**STAFF REVIEW AND RECOMMENDATIONS
PUBLIC HEARING
DECEMBER 2, 2021**

PRELIMINARY PLAT: MT PILOT PH II; VARIANCE
 LEGAL DESCRIPTION: SEC 02, T17N, R01E, SEWARD MERIDIAN AK
 PETITIONERS: SETH AND JEELAN KROENKE
 SURVEYOR/ENGINEER: HANSON LAND SOLUTIONS
 ACRES: 24.23 ± PARCELS: 6
 REVIEWED BY: KIMBERLY MCCLURE CASE #: 2021-158

REQUEST: The request is to create six lots from Lots 1, 2, 4 and Tract A, Mt. Pilot Phase I, Plat No. 2018-106, to be known as **MT. PILOT PHASE II**, containing 24.23 acres +/- . The proposed lots must access from N. Mount Pilot Circle or E. Marcell Circle; no direct access will be granted to Trunk Road. The plat is located east of N. Trunk Road, south of E. Palmer-Wasilla Highway and west of N. Golden Hills Drive; located within the SW ¼ Section 02, Township 17 North, Range 01 East, Seward Meridian, Alaska. Petitioner is requesting a variance from depth to width ratio pursuant to MSB 43.20.300(C).

TEST HOLE LOCATION EXHIBIT MAP

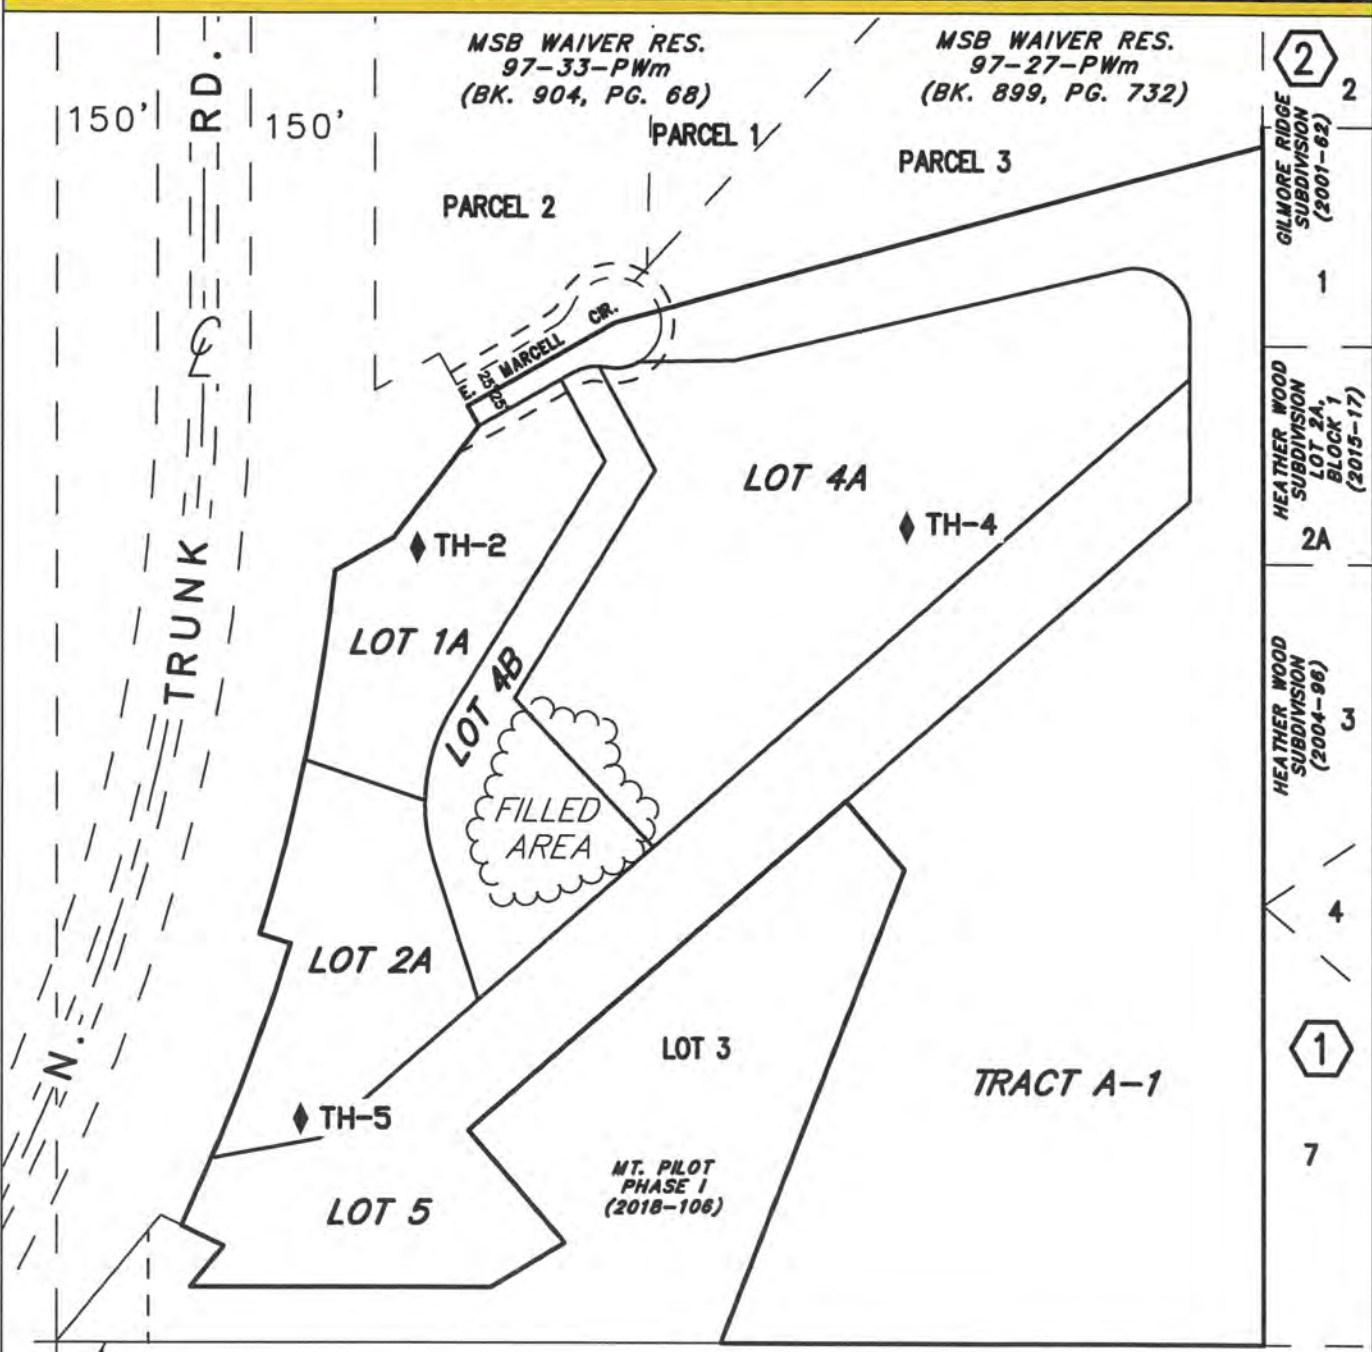
Could you address the fill material on lot 4B in the report and show the areas on the test hole location map? It sounds like the area for Lot 5 would be inside the private access easement – would the installation of a septic system conflict with the intended use of the easement or would it affect the FAA approval of the runway?

Where is the useable area on Lots 4B & 5? From the topo map provided, it appears that a large hole that covered the majority of proposed Lot 4B was filled in, but with what type of soils? And proposed Lot 5, outside of the runway, contains a similar large hole, the bottom of which is at least 25' below the bottom of TH-5.

See report and attached test hole map showing filled area.

Yes the usable area is within the private access easement however the easement is a surface NOT a subsurface easement and the existing driveway is outside the proposed usable area. At the easements width there is plenty of space to widen the driveway if necessary without entering the proposed usable area. Further, properly protected absorption systems can be placed under trafficed areas so proximity to driveway, runway, parking, etc are not an issue to final functionality of any future installed systems on this parcel. Hence, no the installation of a septic system will not conflict with the intended or functional use of the easement.

Lot 4B was been filled a while ago with GW material. Contiguous usable area is setback away from the steep slopes to north along the SE edge adjacent to runway.

Lot 5 usable area is in the SW end of the lot; again setback from the slope down to Trunk Rd and the hole that is adjacent to Lot 3 which puts the contiguous usable area off the SW end of the runway.

EXHIBIT K - 2

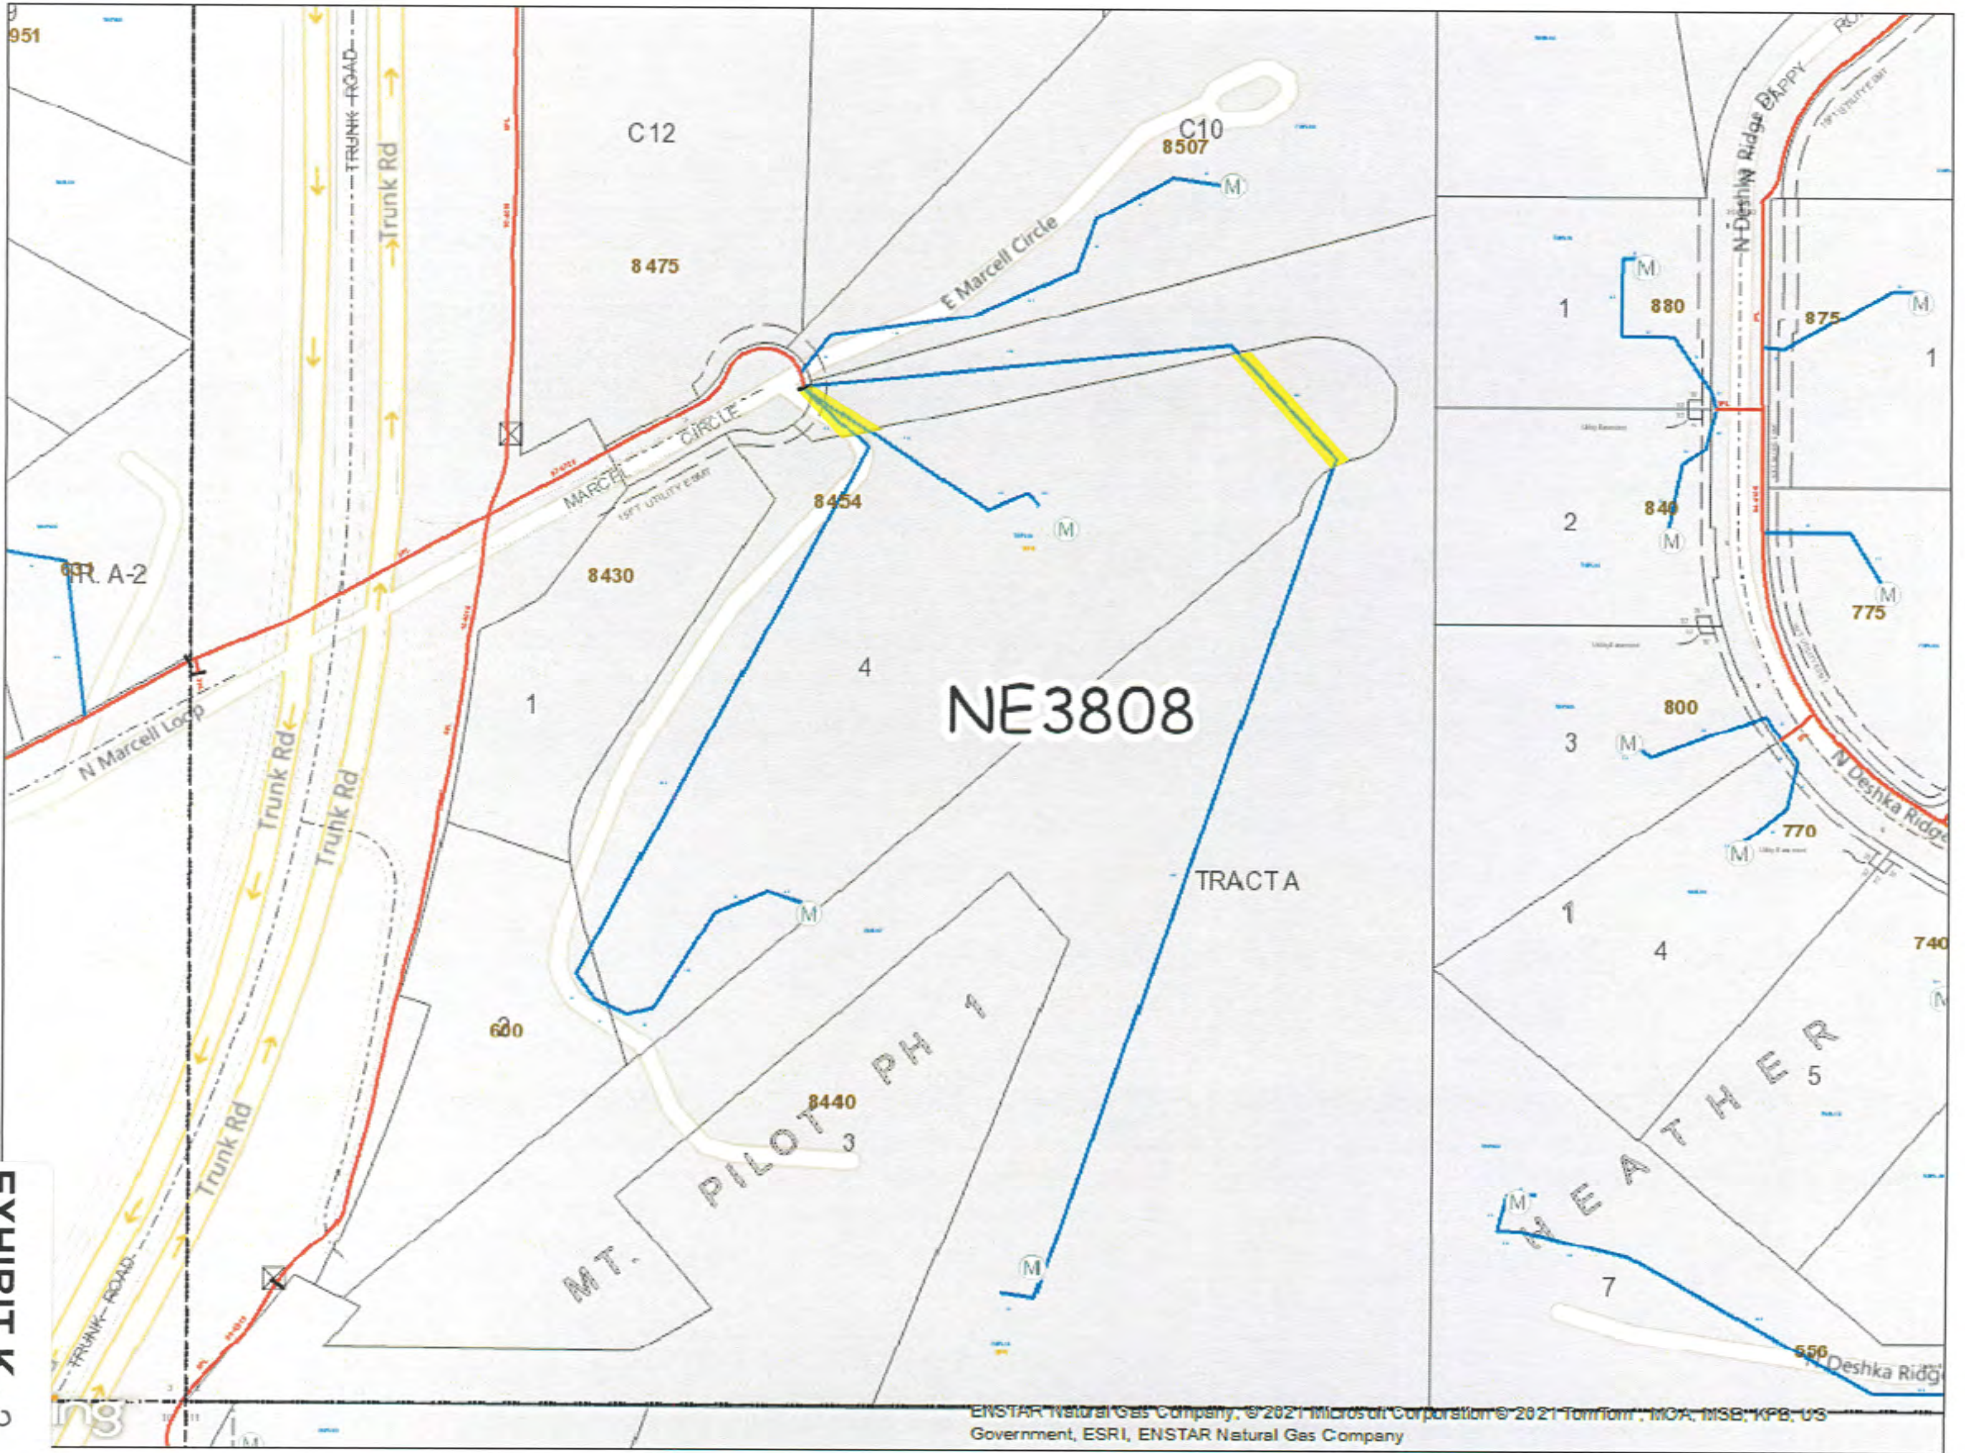
1. Add a note which says, "There is a ten foot (10 FT) wide natural gas easement centered on the existing service lines." And draw in the approximate location of the service lines on the map and add, "Approximate location of natural gas service line and centerline of ten foot (10 FT) wide natural gas easement".
2. Owner signs an ENSTAR Natural Gas Easement document for a ten foot (10 FT) wide natural gas easement, centered on the service line at this location.
